Additional Section 92 Request for Information: BUN60440759 – 362 Jones Road, Drury				
Item	Information Request	Applicant's Response (as dated)	Council Response (as dated)	Applicant's Response (as dated)

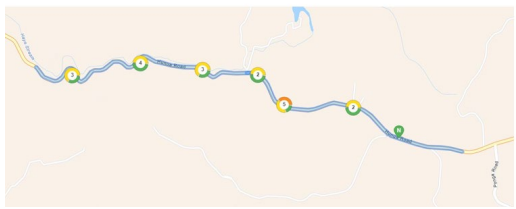
4(d)	Hunua Road caters for school bus stops (that are unmarked) for school children getting picked up and dropped off by the school buses. Can the Applicant identify where these stop locations are and demonstrate whether Scarbro trucks have adverse safety effects on school children.	<p>13/10/2025</p> <p>Response from Commute.</p> <p>Rural bus stops are generally not sign-posted due to being in a rural area and a subject to change (depending on where school children live). From the Hunua School PTA submissions the current stops are listed as:</p> <ul style="list-style-type: none"> 1852 Hunua Road (opposite the site entrance) Hunua Road at Gillespie Road, Hunua Hunua Road at Middleton Road, Hunua 1712 Hunua Road, Hunua (top of the gorge hill) 896 Hunua Road (bottom of the gorge hill) Walkers Bush, Hunua Road, Papakura 	<p>AT are particular concerned with the increase in safety risk of school children in this scenario. The applicant should suggest mitigation measures to reduce any adverse safety effects such as (but not limited to):</p> <ul style="list-style-type: none"> Mark and signpost existing informal bus stops with clear signage. Warning signs for "School Bus Stop Ahead" and "Children Crossing" for truck drivers to see. Truck scheduling to avoid peak school transport times Provide a TMP that coordinates with local schools and bus operators to understand exact stop locations and timing. 	<p>24/11/2025</p> <p>Refer</p> <p>Commute, Technical Memo 24 November 2025</p> <ul style="list-style-type: none"> The rural nature of school bus stops means the stops can change exact location (depending of which houses / areas house school children). It is considered impractical to avoid trucks travelling in the area at peak school transport times and would lead to trucks unnecessarily stopping on the road waiting for school periods to finish. These areas are not typically in the gorge itself. As noted in the traffic report / s92, Hunua Road already carry large number of heavy vehicles. Even outside the site entrance (east of the gorge) the 2024 traffic survey recorded a Heavy Commercial Vehicle (HCV) volume of approximately 27.3% of the 5-day volume of 1,921 vehicles per day (524 heavy vehicles per day). As such trucks travelling in the area with school bus / children is common. The traffic count recording is included with this response. The proposal adds an average of 54 truck movement per day. This is an

Additional Section 92 Request for Information: BUN60440759 – 362 Jones Road, Drury				
Item	Information Request	Applicant's Response (as dated)	Council Response (as dated)	Applicant's Response (as dated)
				<p>increase of 2.8% of total volume and 10% of total heavy vehicles. As such the increase is minimal in regards to the overall existing environment.</p> <ul style="list-style-type: none"> We do however agree that the inclusion of W16-6.1 "school bus stop route" signs would be beneficial for truck / school children safety.
4(e)	Hunua Road is often closed during weather events and accidents on the road, limiting the use and access of Hunua Road. Can the Applicant confirm what temporary traffic management is proposed in a scenario where trucks cannot access the site via Hunua Road and what alternative routes they will use to access the site. If other routes are anticipated to be used as a result of this, the Applicant must demonstrate that alternative routes are suitable for the proposed truck volumes during Hunua Road closure events.	<p>13/10/2025</p> <p>Response from Commute.</p> <p>Should Hunua Road be closed then the Scarbro fill site would also need to close. No other routes will be used.</p>	Noted. No further questions
